NRC DISTRIBUTION FOR PART 50 DOCKET MATERIAL		U.S. NUCLEAR REGULATORY COMMISSION		DOCKET NUMBER 50-331	
TO: G. LEAR		FROM: IOWA ELEC LIGHT & POWER CEDAR RAPIDS, IOWA L. LIU		FILE NUMBER Misc 4	
				DATE OF DOCUMENT 10-19-76	
				DATE RECEIVED 10-21-76	
<input checked="" type="checkbox"/> LETTER <input type="checkbox"/> ORIGINAL <input type="checkbox"/> COPY		<input type="checkbox"/> NOTORIZED <input checked="" type="checkbox"/> UNCLASSIFIED		NUMBER OF COPIES RECEIVED 40	
DESCRIPTION LTR. RE. OUR 8-11-76 LTR.....TRANS THE FOLLOWING.			ENCLOSURE RESPONSE TO REQUEST FOR AN EVALUATION OF THE DUANE ARNOLD ENERGY CENTER WITH REGARD TO THE DEGRADED VOLTAGE CONDITION.....  ( 1 SIGNED CY. RECEIVED) ( 27 PAGES)  <div style="text-align: center; font-size: 1.2em; font-weight: bold;">DO NOT REMOVE</div>  <div style="text-align: center; font-size: 1.5em; font-weight: bold;">ACKNOWLEDGED</div>		
<div style="display: flex; justify-content: space-between;"> <div>PLANT NAME: DUANE ARNOLD</div> </div>

October 19, 1976  
IE-76-1590

This letter is in response to your letter of August 11, 1976 requesting an evaluation of the Duane Arnold Energy Center (DAEC) with regard to the degraded voltage conditi

FIGURE 1

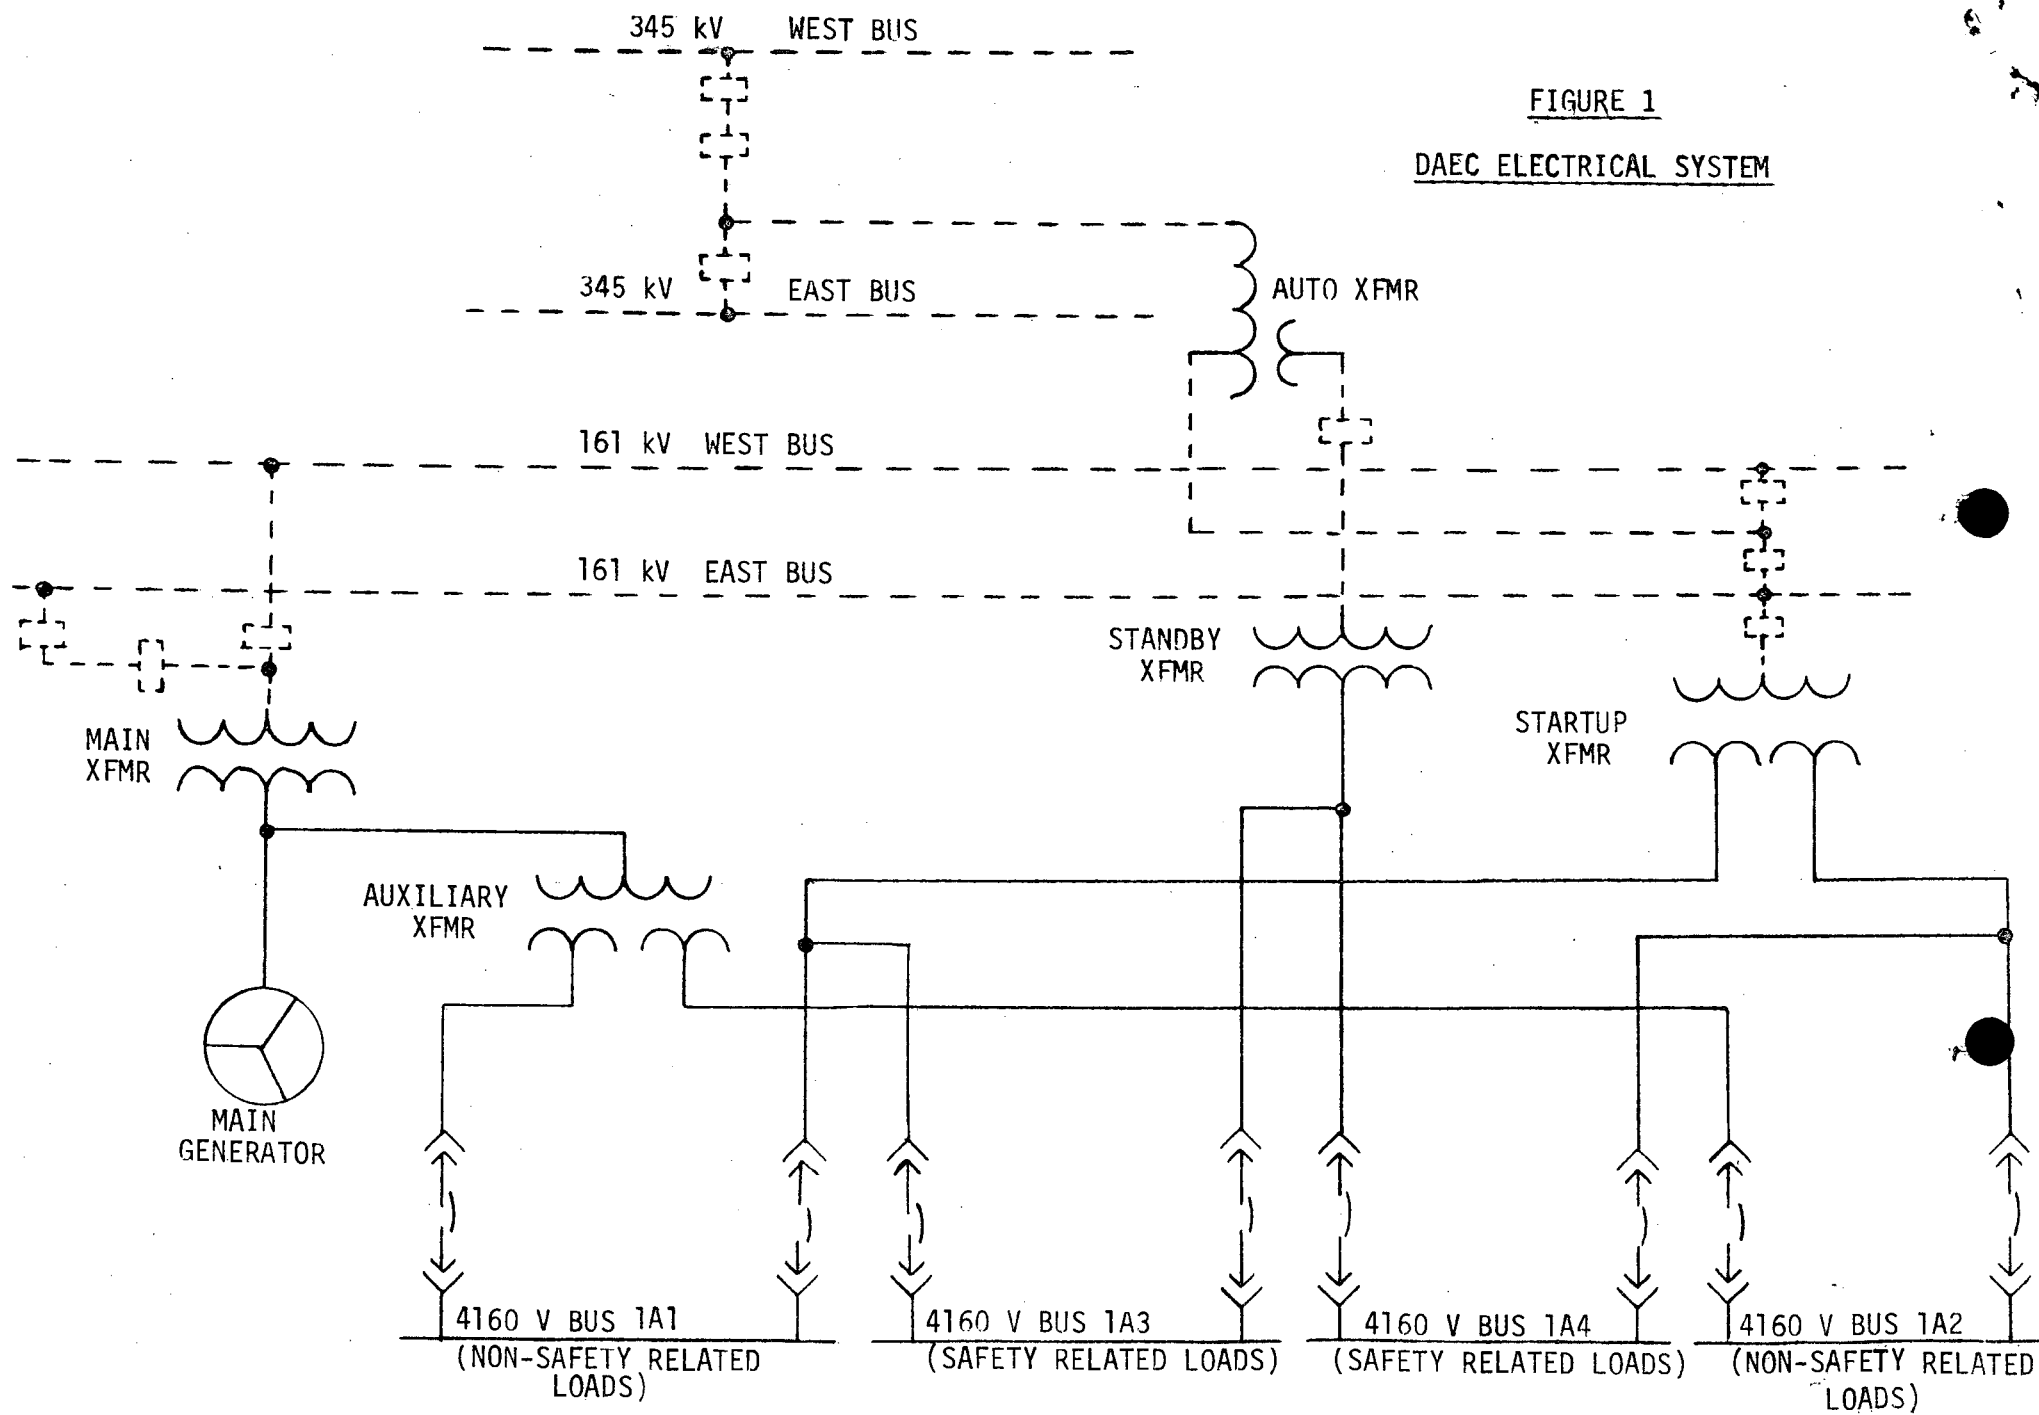
Describe the plant conditions under which the plant auxiliary systems (safety related and non-safety related) will be supplied by offsite power. Include an estimate of the fraction of normal plant operating time in which this is the case.

The safety related loads are supplied by offsite power at all times except during testing of the diesel generators. Normally the safety related loads are supplied from the 161 kV transmission system through the startup transformer. During maintenance of the startup transformer, the safety related loads are supplied from the 161 kV or the 345 kV transmission system through the standby transformer. The safety related loads are supplied by offsite power for all but an estimated one day per year during diesel generator testing. Refer to the attached Figure 1 and Section 8 of the FSAR for a description of the plant electrical power systems.
